CAP 1886 ANNEX E

CAA Analysis of SurveyMonkey feedback from stakeholders and members of the public

Figure 1

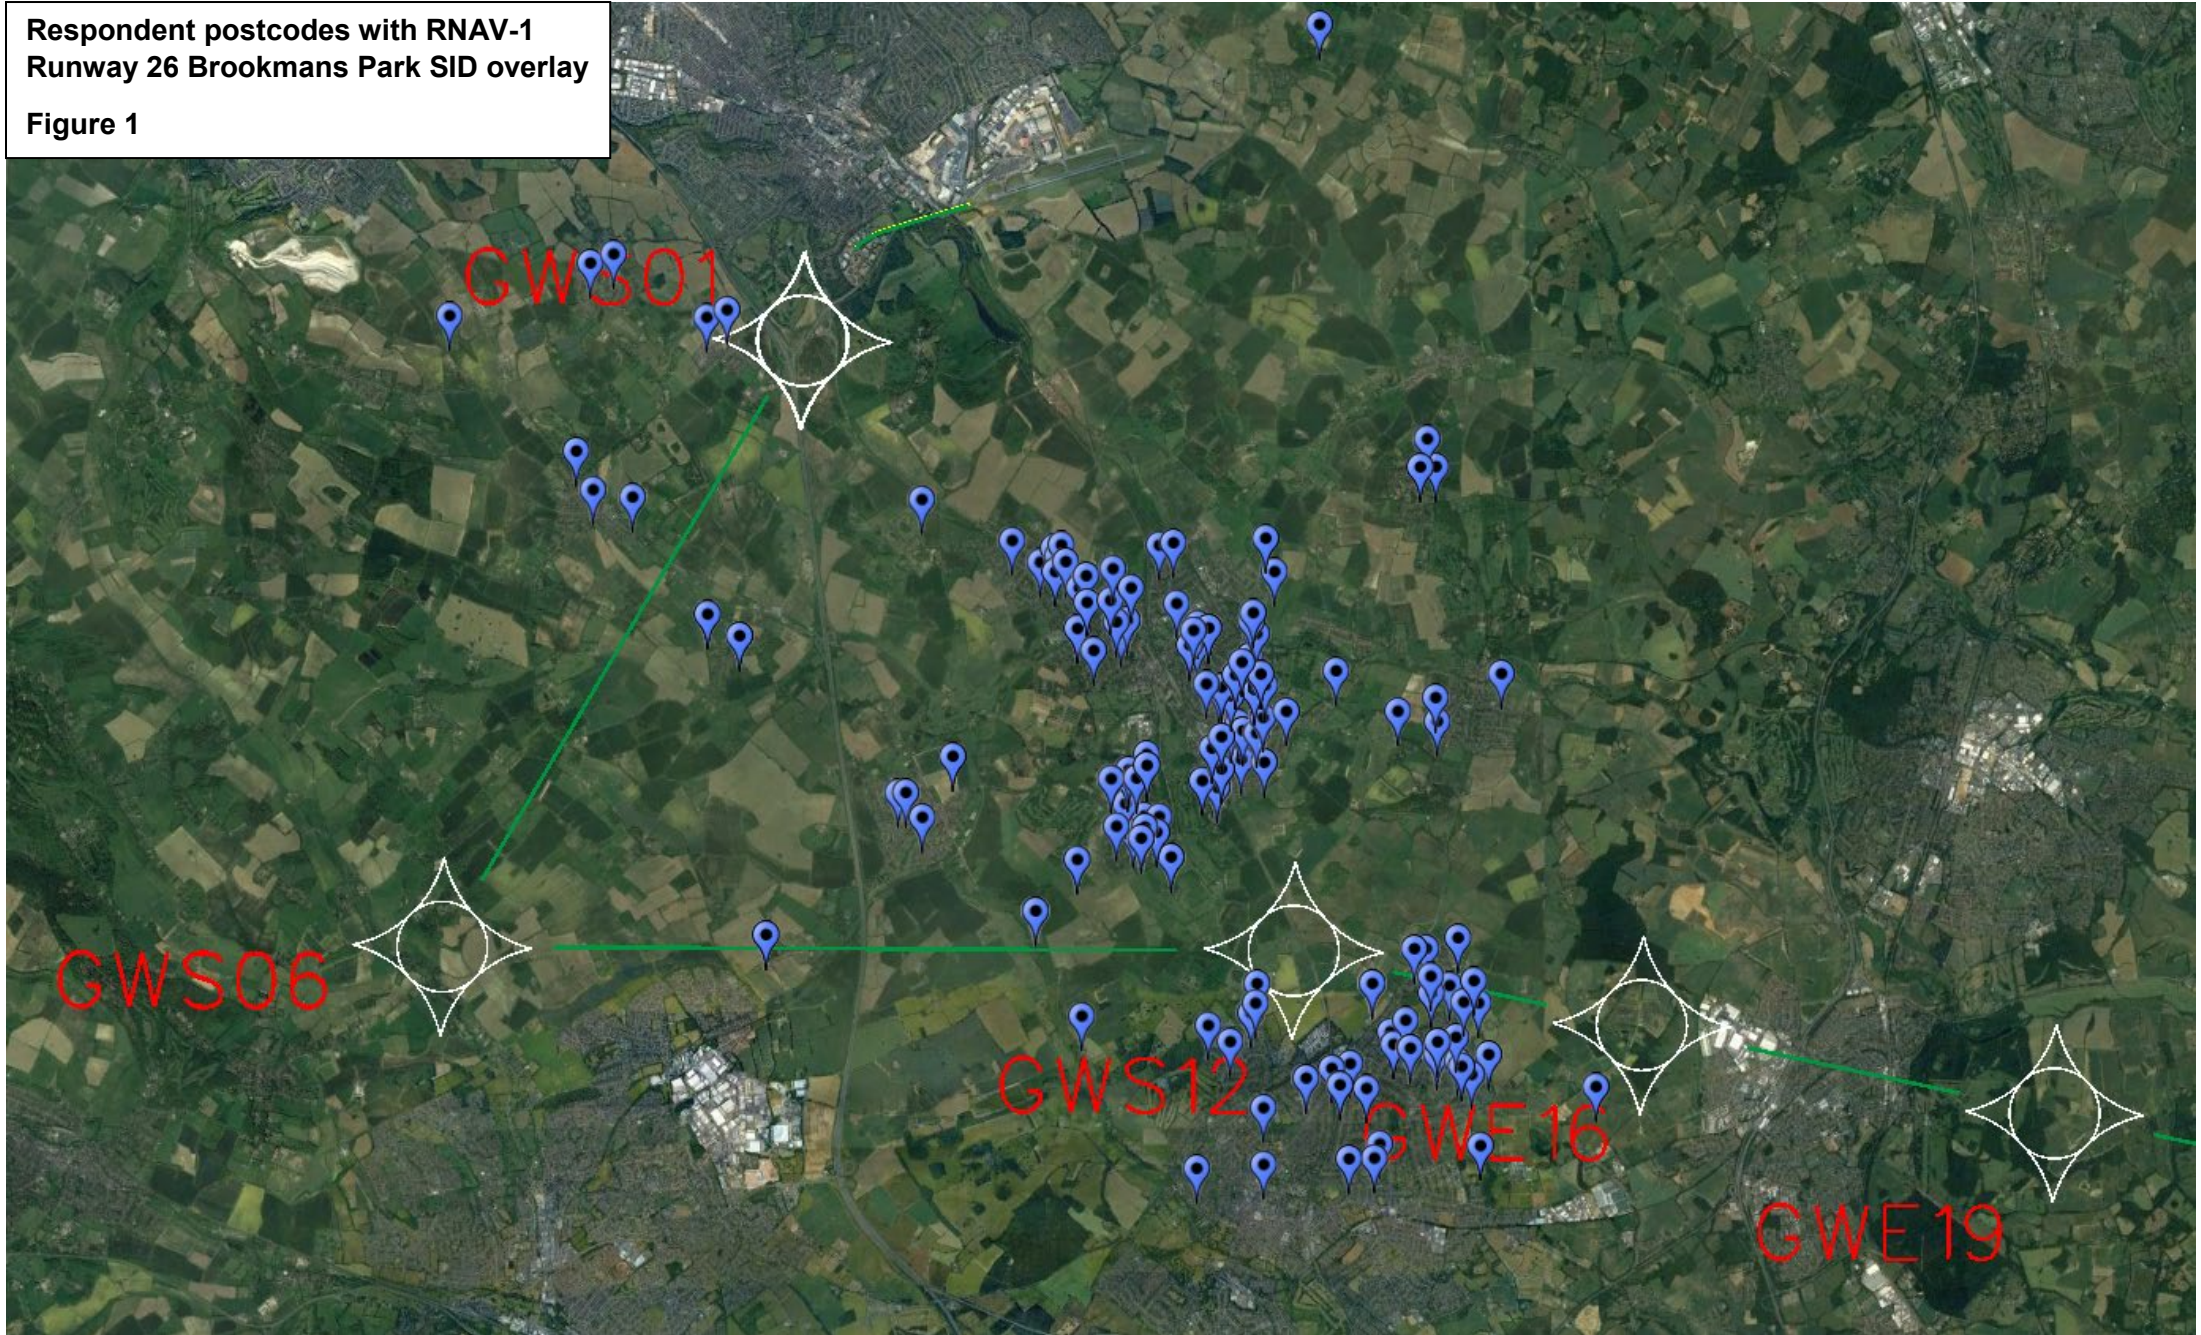
(7) Areas affected. Stakeholders referred to the following areas being affected by a significant increase in noise: Harpenden, St Albans (including Batchwood, New Greens and Marshalswick), Sandridge including Heartwood Forest and Jersey Farm, Southdown, Redbourn, Childwickbury, Hatfield, Hemel Hempstead, Caddington, Wheathampstead and West Essex. Google Earth landscape images are included within this Annex at page 34. Participants' postcodes were plotted on Google Earth with overlays including google maps (Figure 2) and the RNAV-1 Runway 26 Brookmans Park SID overlay (Figure 1).

Following a review of the data LLAOL submitted for the purpose of this PIR, the anticipated noise impacts from the introduction of the RNAV-1 SIDs are as the CAA expected. For further details, please refer to the main PIR document.
